### National Highways Planning Response (HEPR 16-01)

### Formal Recommendation to an Application for Planning Permission

Council's Reference: LCC/2021/0007

Referring to the notification of a planning consultation dated 16<sup>th</sup> February 2021 for the prior extraction of sand / gravel and subsequent restoration with inert engineering fill to facilitate a platform for employment development or agriculture with peripheral landscaping on land north of the A674 Millennium Way, north east of M61 Junction 8 at Chorley, National Highways' formal recommendation is that we:

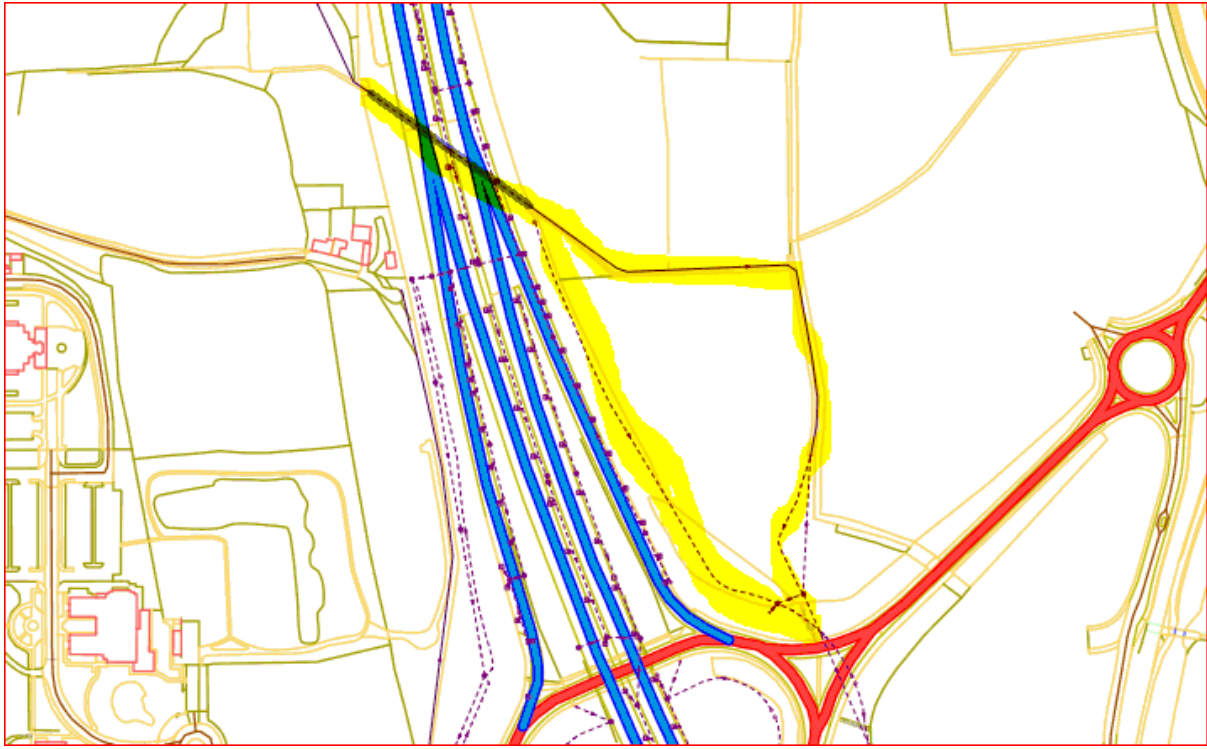
A motorway filter drain runs along the motorway boundary with this site at the foot of the motorway embankment., as shown in the drawing below. **Again, there will need to be a level of standoff agreed with National Highways from the excavation to ensure that this drain is not disturbed.**
